Product Change Notification / ASER-15CAKZ286

CCB 4630.001 Initial Notice: Qualification of STA as an additional assembly site for selected CAP1188 and USB33xx device families available in 24L VQFN (4x4x0.9mm) package.

PCN #: ASER-29WFJP505

**Qualification of MTAI as an additional assembly site for
selected ATA66xx device family available in 8L SOIC
(3.90mm) package.**

Lead Frame Comparison – Fused 3

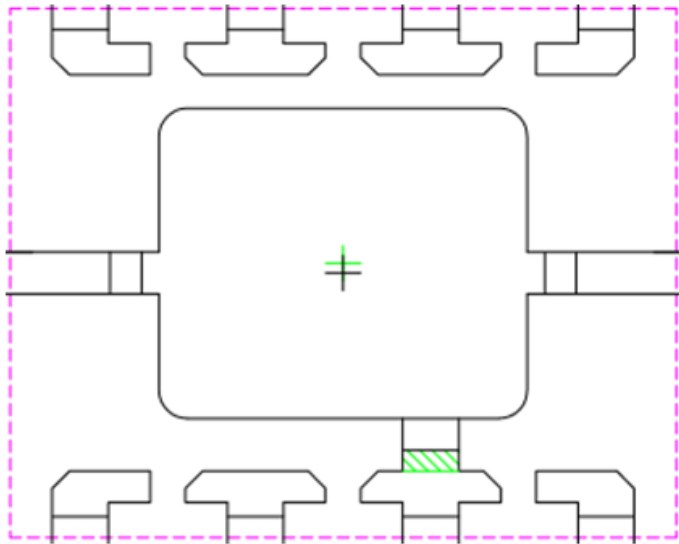
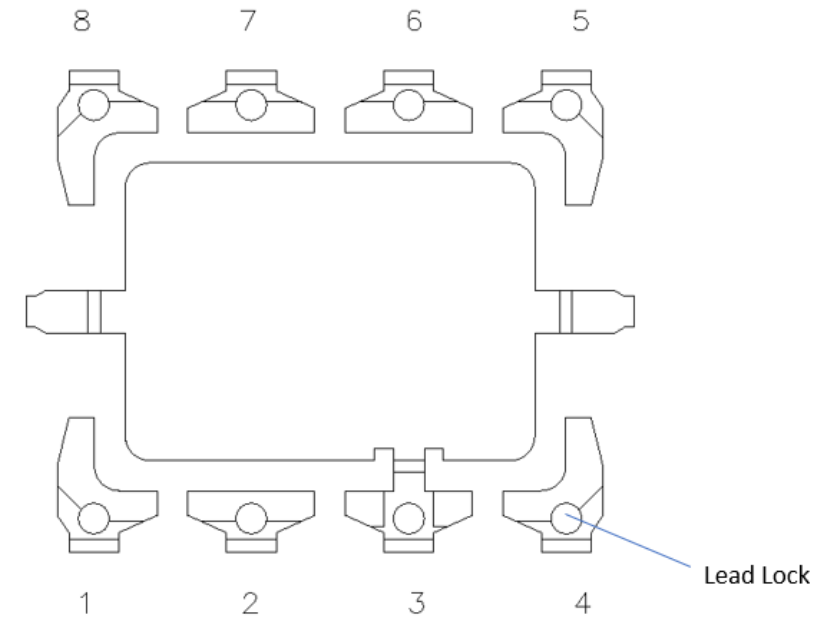
ANAP

Without lead lock

Die pad size: 2,667 x 2,235mm

MTAI

With lead lock

Die pad size: 3,300 x 2,413mm

Lead Frame Comparison – Fused 5

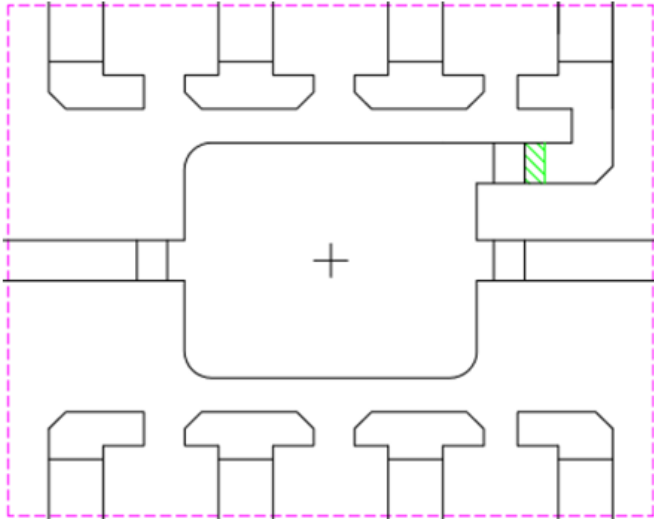
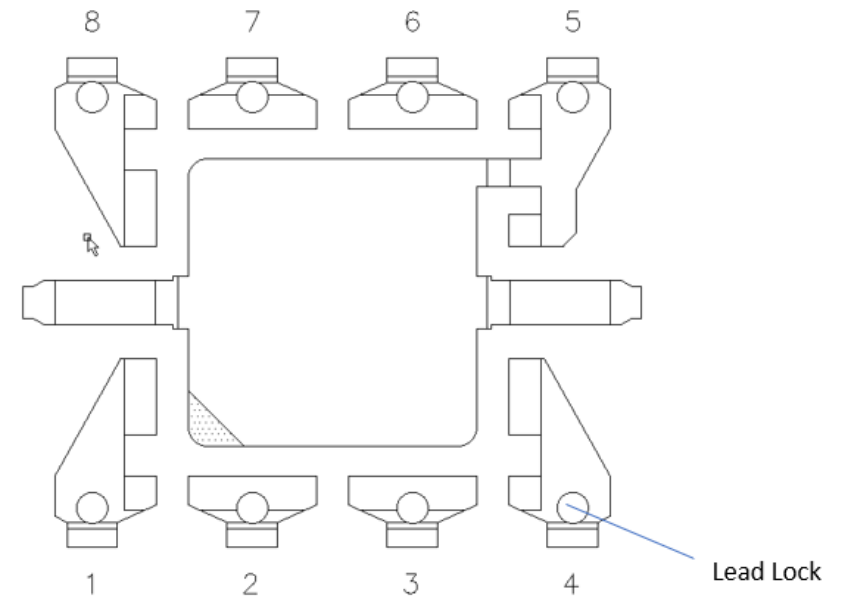
ANAP
Without lead lock
Die pad size: 1,778 x 2,184mm

MTAI
With lead lock
Die pad size: 2,286 x 2,286mm
